TRANSPORT AND WORKS ACT 1992
TRANSPORT AND WORKS (INQUIRIES PROCEDURE) RULES 2004
PROPOSED NETWORK RAIL
(STALYBRIDGE TO DIGGLE (SADDLEWORTH) ENHANCEMENTS) ORDER

Proof of Evidence

Stuart Catterall
BEng (Hons) ACGI CEng MICE

Canal & River Trust

Fig. 1 - GIS Extract of Diggle Feeder route to Standedge Tunnel (assumed) beneath Station Road Bridge, Brunclough Feeder & Brunclough abstraction orifice.

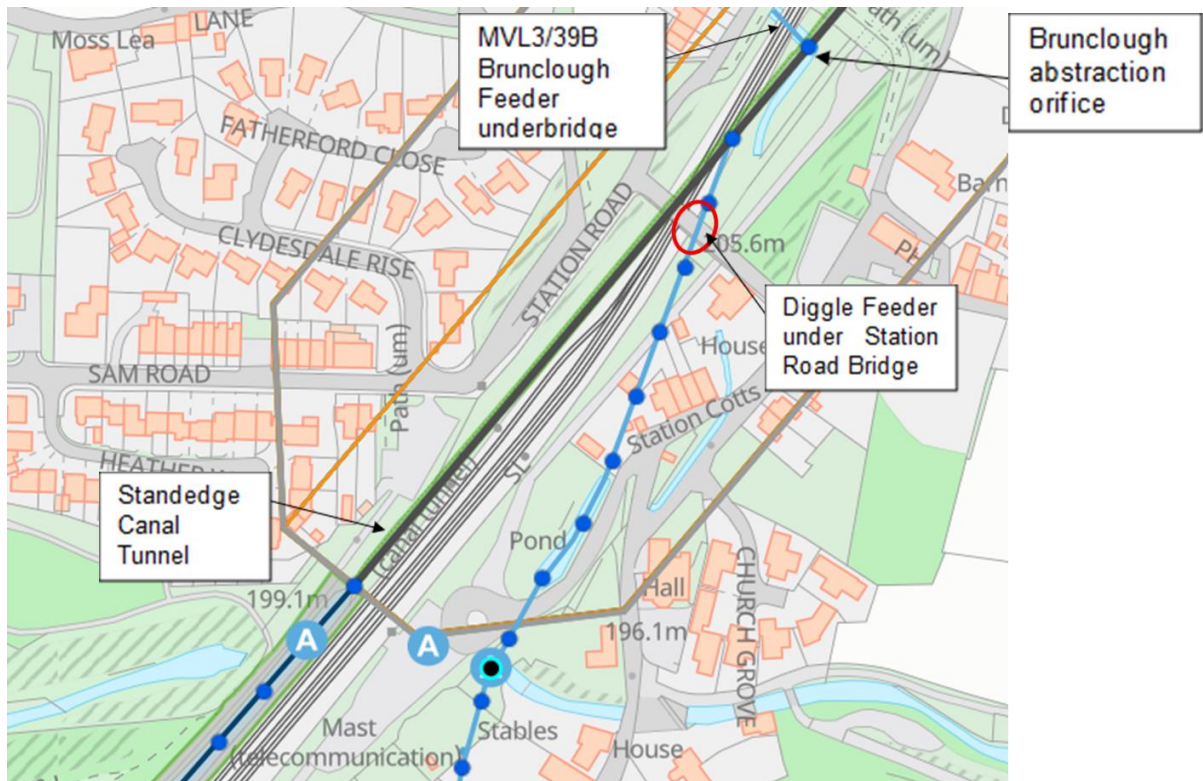
5.1 Diggle Feeder is culverted underground from an open channel to the south of Station Cottages to a point where it discharges directly into Standedge Tunnel (the exact location of the outfall to the tunnel is unknown). The assumed alignment is shown in the GIS extract at Fig. 1, above. This shows the culverted feeder passing directly beneath Station Road overbridge (MVL3/39) and will potentially be affected by the proposed foundation works for the proposed Overbridge due to its potential close proximity.

5.2 It is therefore imperative that the actual alignment of the culvert is traced and that a pre-works internal condition assessment is carried out of the Diggle culvert in order to ensure that the permanent works design of the new Station Road overbridge foundation does not adversely affect the existing feeder culvert. A post-works internal condition assessment is also required to confirm that the culvert has not been damaged during the course of the bridge construction work. As set out at section 11 in the evidence of Tim Bettany-Simmons (OBJ211/TBS/1) this matter could be addressed by a suitably worded condition.

5.3 I am concerned that there is a possibility, which based on my understanding of the Order scheme I cannot rule out, Network Rail may need to block or divert temporarily the Diggle Feeder channel or culvert at some point during the authorised works in order to complete either its temporary or permanent construction work. This would be necessary if there is a clash with the new overbridge foundation and the existing feeder or if construction plant were to overload the culvert for example. If a temporary blockage or diversion is required, then the flow will need to be managed in order to maintain the supply of water to the HNC. This may take the form of over-pumping using temporary pumps to pump water from the feeder channel, past the proposed works and back into the feeder so that it discharges to the canal. My understanding of an attempt by Network Rail in 2024 to over-pump the Diggle Feeder was that it was not successful, due to the pumps that were provided being under-sized. Therefore, any attempt to over-pump as part of the Order scheme would need to be carried out by agreement with the Trust. Such an exercise would need to maintain appropriate flow rates in order to ensure that a satisfactory supply of water is provided to the HNC. More details about the feeders' supply required for the HNC is provided at sections 3.2 and 3.3 in Dr. Comerford's proof of evidence (OBJ211/AC/1).
